PIC32MX1XX/2XX/5XX 64/100-pin Family

Silicon Errata and Data Sheet Clarification

The PIC32MX1XX/2XX/5XX 64/100-pin family devices that you have received conform functionally to the current Device Data Sheet (DS60001290F), except for the anomalies described in this document.

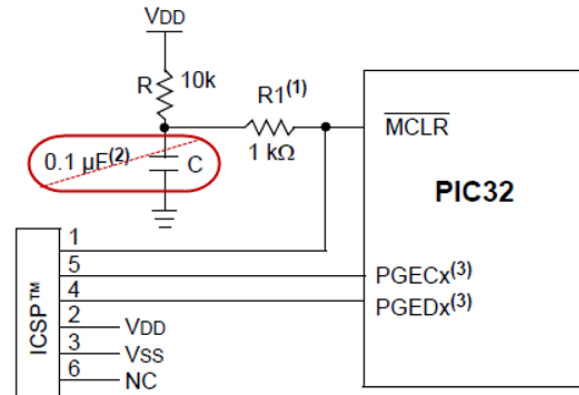
On power-up depending on the VDD ramp rate, the I/O pins can be in an active random output driving state if MCLR is active until a BOR event.

If, not using an external reset supervisor IC or equivalent, remove the MCLR capacitor as shown below, and retain the MCLR Pull-up resistor.

If using an external reset supervisor IC or equivalent, increase the value of the VCAP capacitor to ≥47 µF ceramic or solid tantalum capacitor with an ESR ≤ 1 ohm.
